IN THE DRAWINGS

Marked Amended Sheet
Appl. No. 09/751,214

Fig. 3a

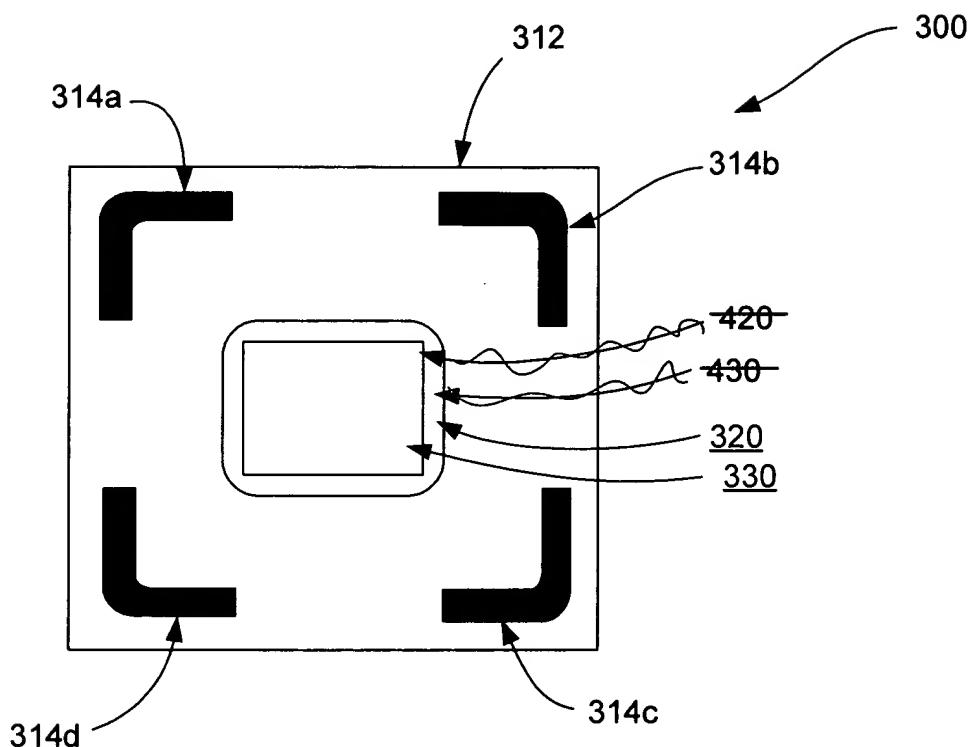
Specifically, the labels 420 and 430 have been correctively amended to read 320 and 330 respectively. This correction brings Figure 3a into agreement with the specification as amended in applicants' January 1, 2003 response to the October 8, 2002 office action (Applicants' response dated January 1, 2003, page 2, paragraph 1). Thus, by this corrective amendment, the references in the specification to the die 330 and the underfill 320 in Figure 3a now agree with the numbering contained in the amended Figure 3a.

Likewise, the indicator lines leading from the labels 320 and 330 were transposed in the drawings as provided in the January 1, 2003 response, and are amended to point to the correct features. Thus, the indicator line from label 320 is corrected to point to the underfill, and the indicator line from label 330 is corrected to point to the die. These changes also bring the amended Figure 3a into agreement not only with the specification as amended in applicants' January 1, 2003 response ("with underfill 320 shown protruding from underneath and just beyond the edges of die 330"), but also with the

similar die and underfill features shown in Figure 4a, (320 in Figure 3a corresponding to 420 in Figure 4a, etc.).

The application serial number has been added as identifying indicia on the front of the sheet for Figure 3a in accordance with 37 CFR 1.84(c).
